CURRENT WELLBORE DIAGRAM

St. Mary Land & Exploration NMNM9087: Tuesday Federal 1 810' FSL & 990' FWL Sec. 34, T19S-R29E Eddy County, New Mexico

RE: Plugging and Abandonment Requirements, Conditions of Approval

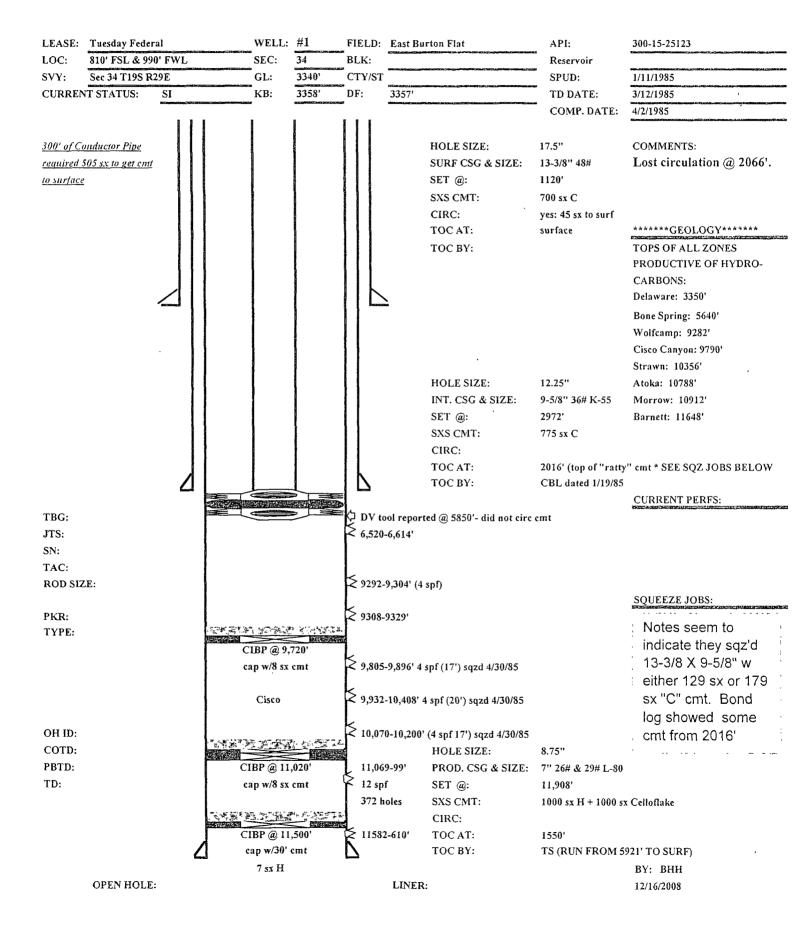
- 1. Set CIBP @ 9280' and cap with 35' cement using a dump bailer or spot a 25 sack plug on top of CIBP.
- 2. Spot a 335' cement plug from 5925'-5590' (covers the DVT and the top of the Bone Spring formation).

- 3. Spot a 130' cement plug from 3415'-3285' (covers the top of the Delaware formation and isolates the Capitan Reef).
- 4. Spot a 130' cement plug from 3037'-2907' (covers the 9-5/8" casing shoe), WOC and tag no lower than 2907'. Note: Plug 3 & 4 could be combined as one plug from 3415'-2907'.

- 5. Perforate the 7" casing @ 1170', squeeze with adequate cement to fill from 1170'-1070' in/out of the 7" casing (covers the 13-3/8" casing shoe). WOC and tag no lower than 1070'.

- 6. Perforate the 7" casing @ 835', squeeze with adequate cement to fill from 835'-735' (covers the base of the salt). WOC and tag no lower than 735'.

- 7. Perforate the 7" casing @ 450', squeeze with adequate cement to fill 7" casing and the annulus of the 7"x 9-5/8" casing from 450' to surface. Cap off as needed.
